UNITED STATES OF AMERICA
FEDERAL ENERGY REGULATORY COMMISSION

Docket No. AD04-6-000

NOTICE OF AVAILABILITY OF STAFF'S RESPONSES
TO COMMENTS ON THE CONSEQUENCE ASSESSMENT METHODS
FOR INCIDENTS INVOLVING RELEASES FROM LIQUEFIED
NATURAL GAS CARRIERS

STAFF'S RESPONSES TO COMMENTS ON *CONSEQUENCE ASSESSMENT METHODS FOR INCIDENTS INVOLVING RELEASES FROM LIQUEFIED NATURAL GAS CARRIERS*

Figure 1 Evaporation Rate Versus Time for Heat Flux Sensitivity

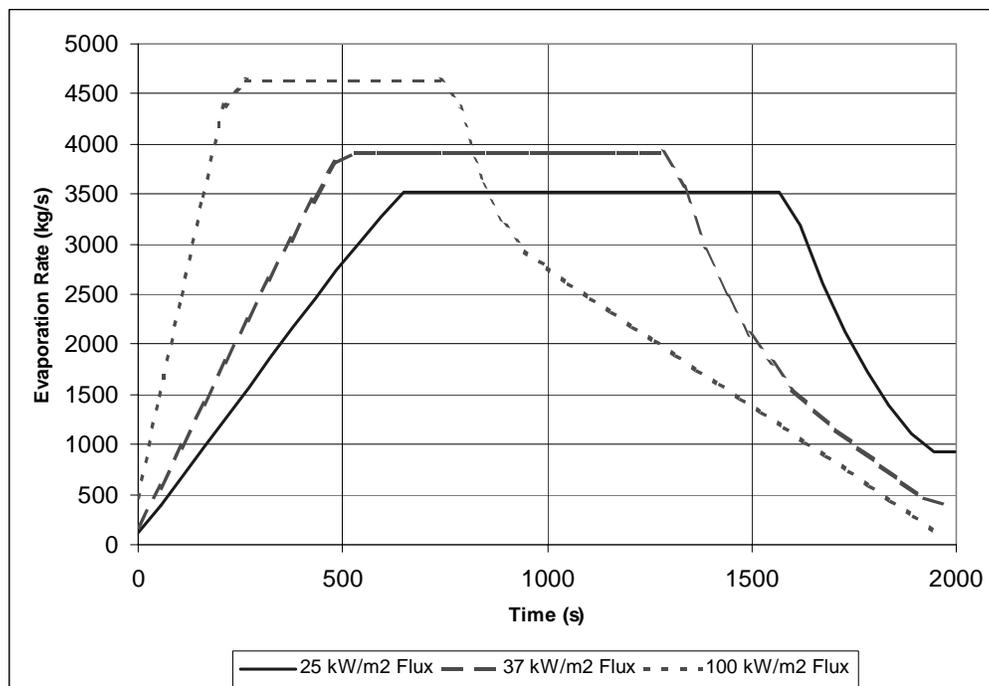
The authors provide a table of comparison of LFL distances obtained for different assumptions for the value of the heat flux from water to LNG pool. The results presented in the table on page 18 are some what counter intuitive. As the heat flux increases (making the vapor generation rate higher) the down wind flammable distance for an unignited cloud decreases. This is completely contrary to what one expects; as the source rate increases, all things about the weather conditions being the same, the down wind LFL distance increases.

While the spill rate and duration are the same for all three cases, the transient evaporation rate looks different for each case because of the differences in heat flux values and corresponding differences in pool spread. Figure 1 shows the evaporation rate versus time for all three heat flux values.

These differences in transient evaporation account for the counterintuitive trend in heat flux and downwind distance to the LFL.
